35/13-03Y 16 Newland's Street
Chevy Chase Village Historic District

SUBJECT: Historic Area Work Permit # 324579

The Montgomery County Historic Preservation Commission (HPC) has reviewed the attached application for a Historic Area Work Permit (HAWP). This application was **APPROVED WITH THE FOLLOWING CONDITIONS.**

Address:	16 Newlands Street	Meeting Date:	1/28/04
Resource:	Contributing Resource Chevy Chase Village Historic District	Report Date:	1/21/04
Review:	Revised HAWP	Public Notice:	11/14/03
Case Number:	35/13-03Y	Tax Credit:	No
Applicant:	Dr. Robert and Susan Morgenstein	Staff:	Joey Lampl

VIEW FROM REAR YARD

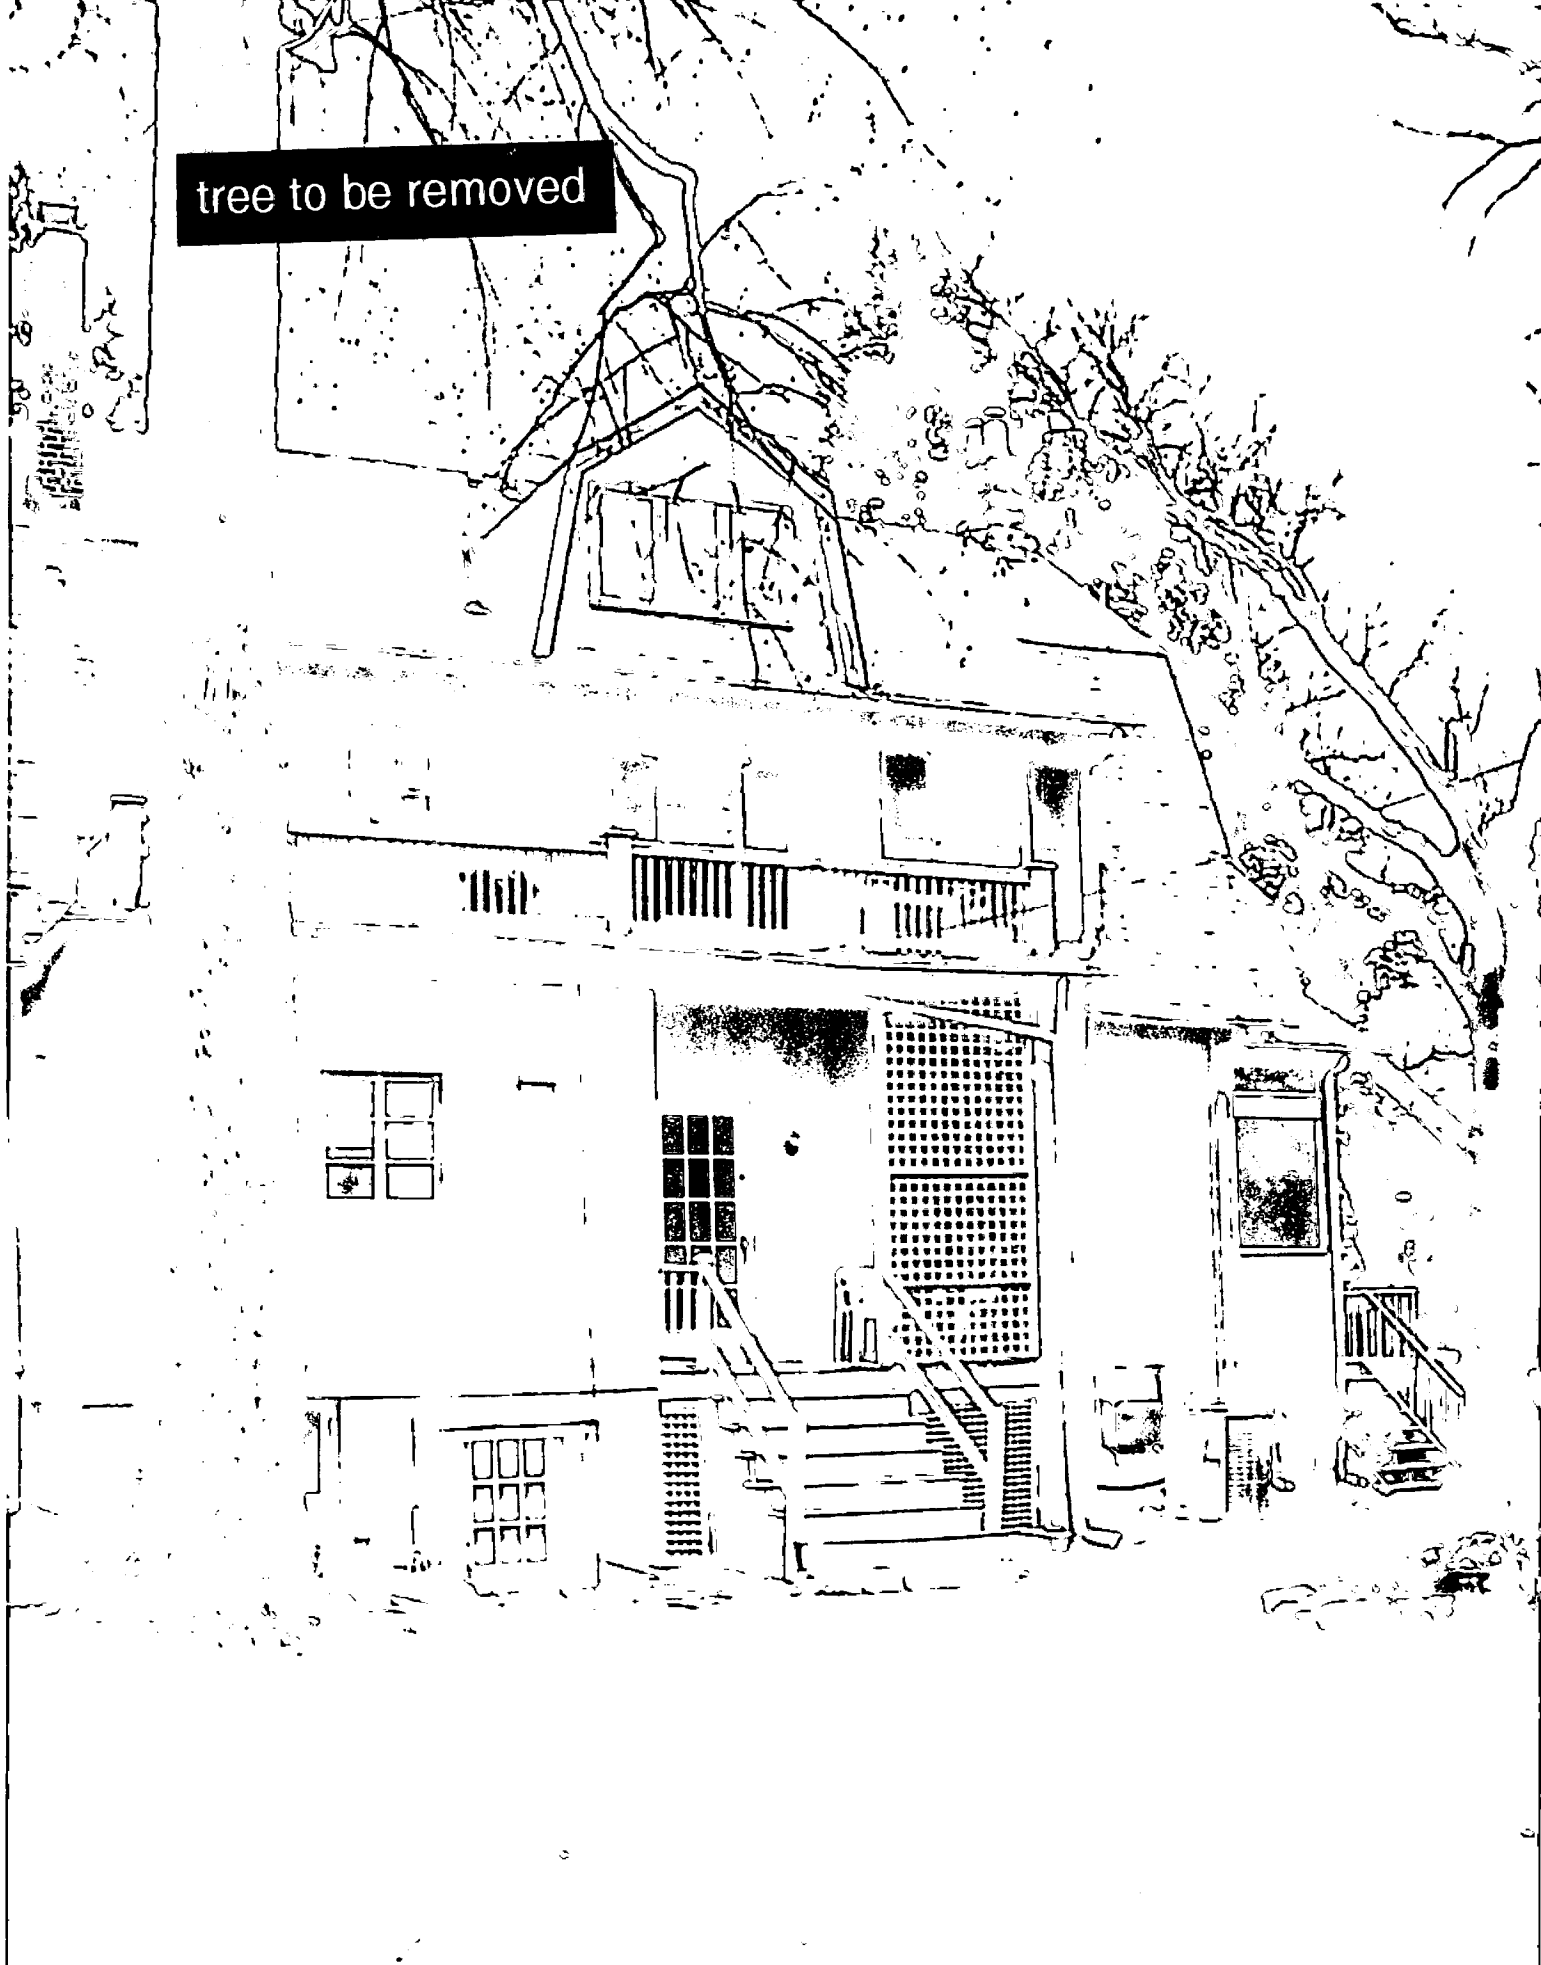
tree to be removed
